## **RFQ#21-28 - ADDENDUM #3**

### **Waterloo City Hall 2nd Floor Office Space Renovation**

**ADDENDUM ISSUE DATE: August 8, 2021**

Subject: **Addendum No. 03**

FINISHES PLAN

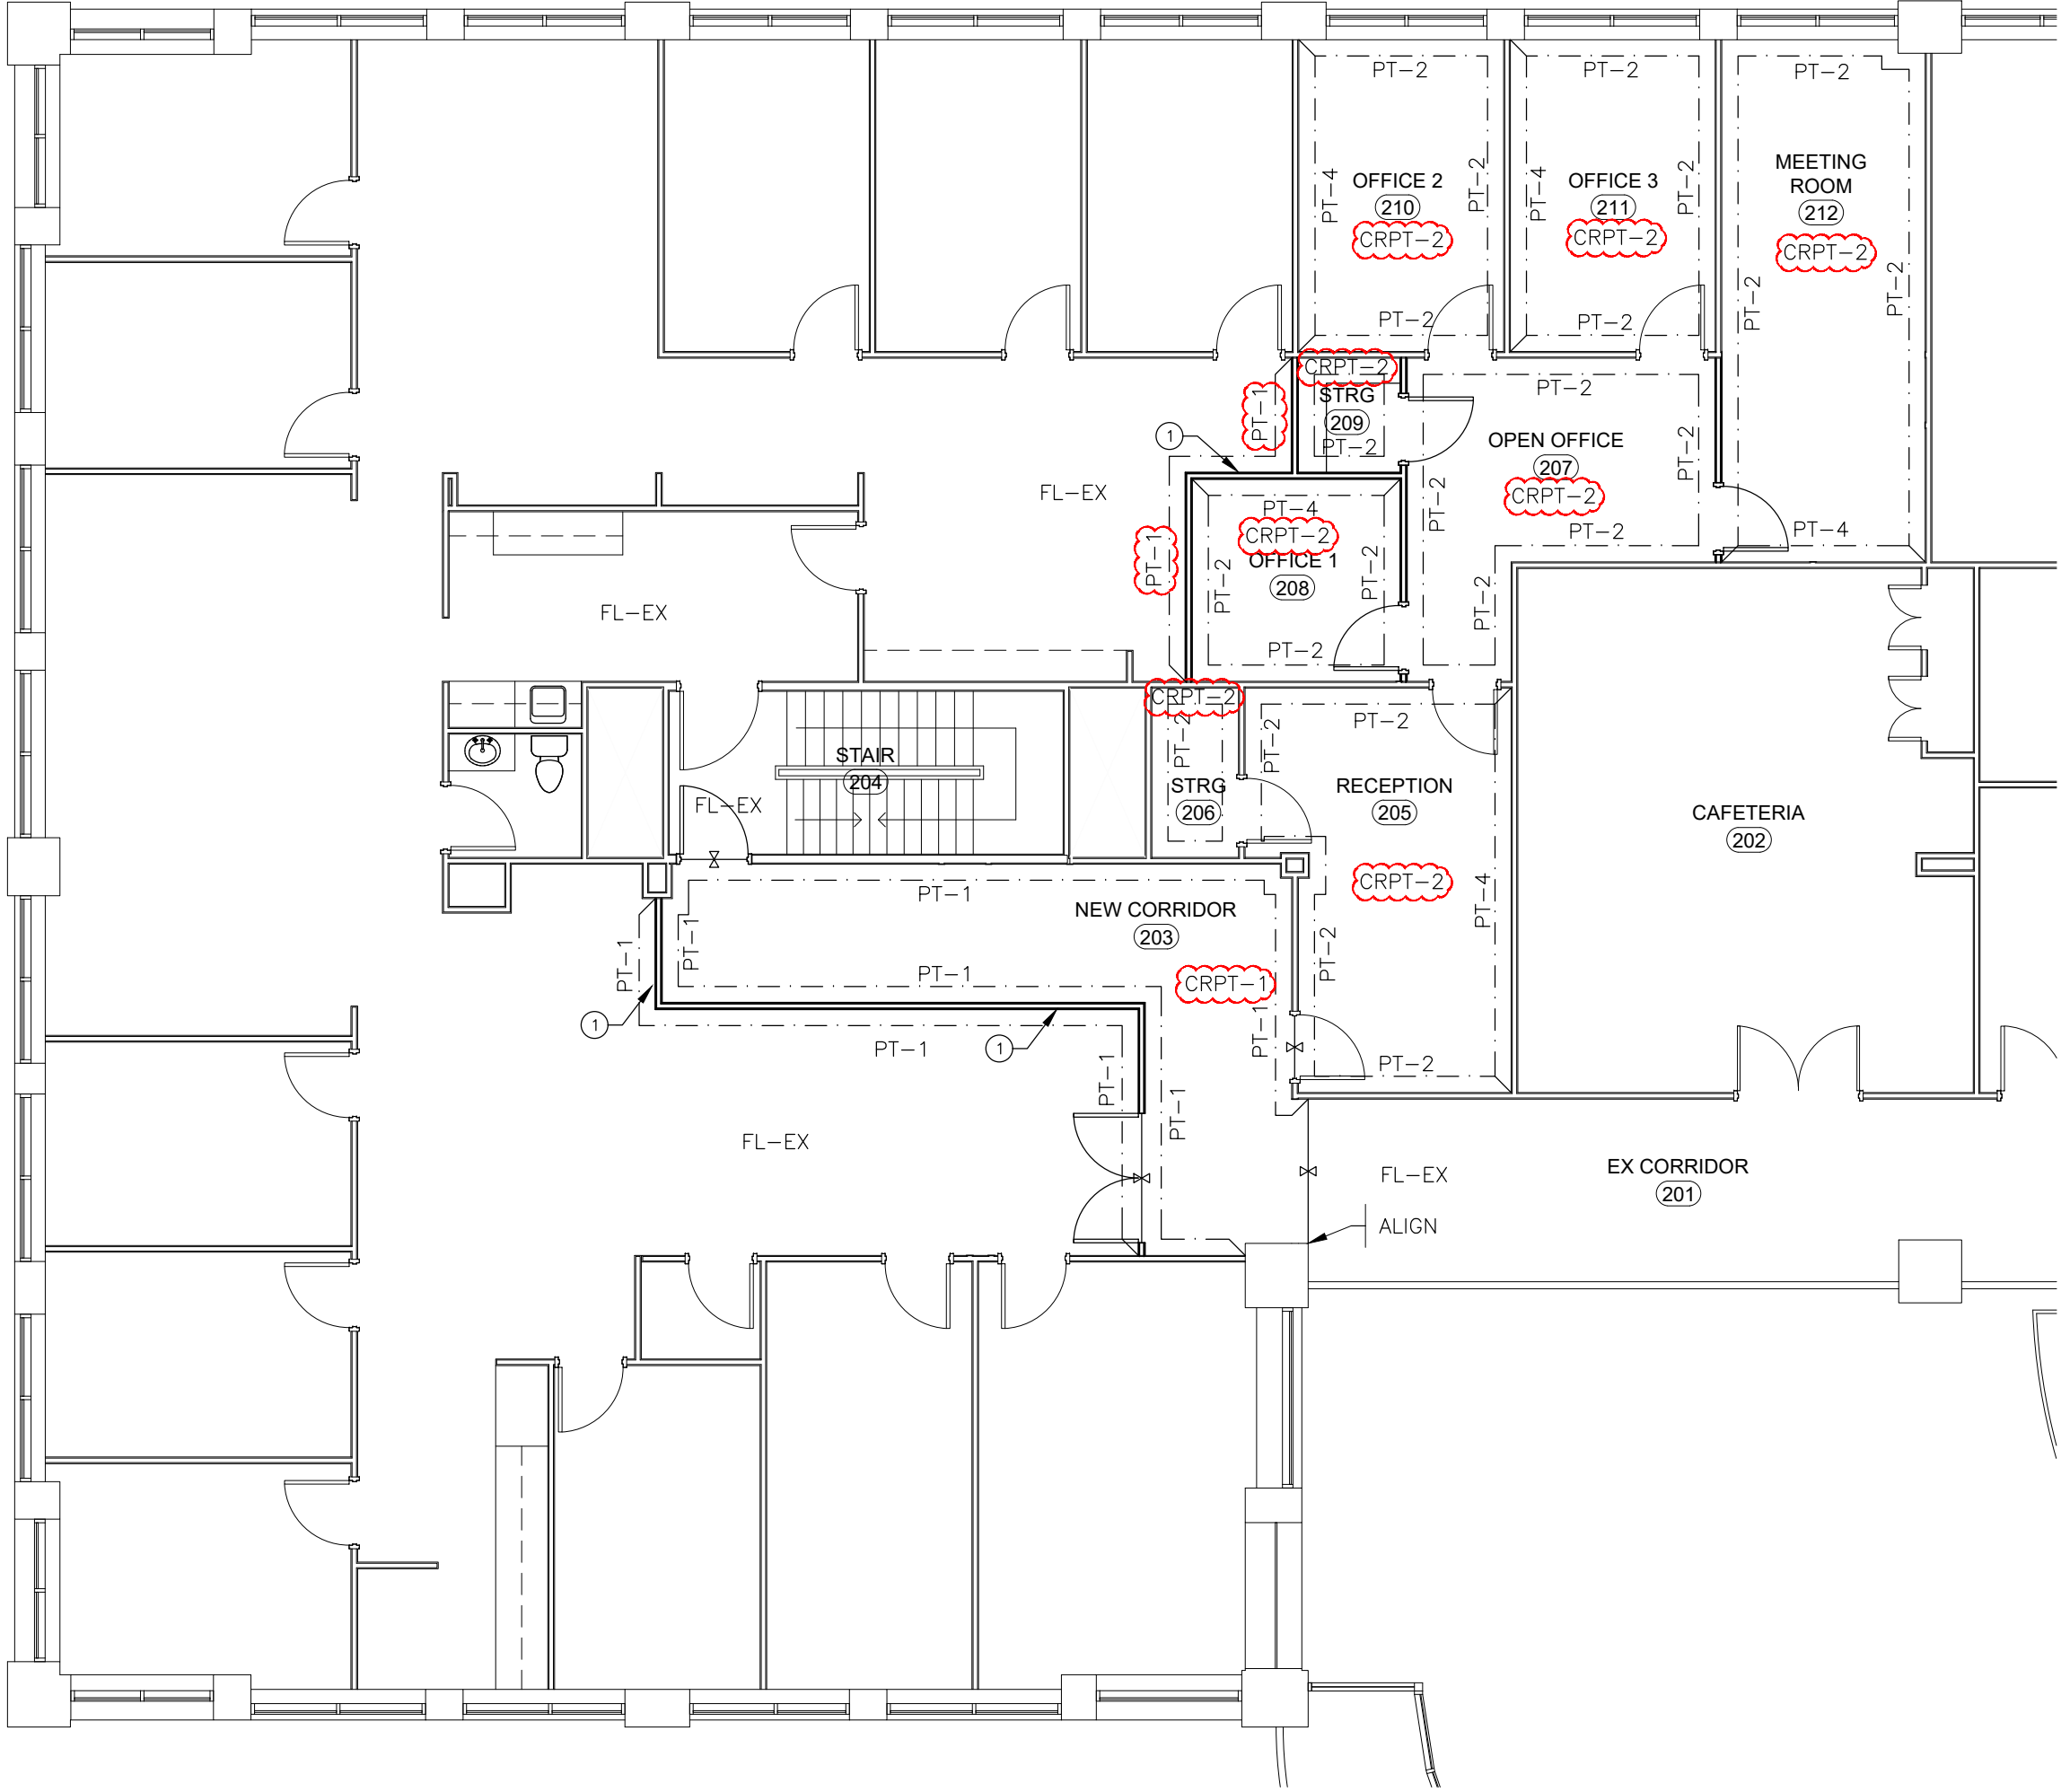
1. New Corridor (Room 203) floor finish to be revised to Carpet, Refer to A2, prepared by IBI Group and Elemental, Issued for Addendum #3, dated 04 Aug 2021 for revisions to finishes.

2. New Tenant Suite (Rooms 205, 206, 207, 208, 209, 210, 211, and 212) floor finish to be revised to CRPT-2, Refer to A2, prepared by IBI Group and Elemental, Issued for Addendum #3, dated 04 Aug 2021 for revisions to finishes.

5. New Door D1 into Stair 204 shall be equipped with a latching mechanism as required by OBC 3.1.8.13 (refer to attached approved building permit drawings and A2, Issued for Addendum #3, dated 04 Aug 2021 for revisions to door schedule). Door hardware to be included under Door Hardware cash allowance.

8. Paint and add a new base board along new walls on unoccupied tenant side. Refer to A2, prepared by IBI Group and Elemental, Issued for Addendum #3, dated 04 Aug 2021

① PROVIDE NEW RUBBER WALL BASE ALONG NEW WALL, ON UNOCCUPIED TENANT SIDE. NEW BASE COLOUR TO MATCH EXISTING (JOHNSONITE, BURNT UMBER 63 TBC).
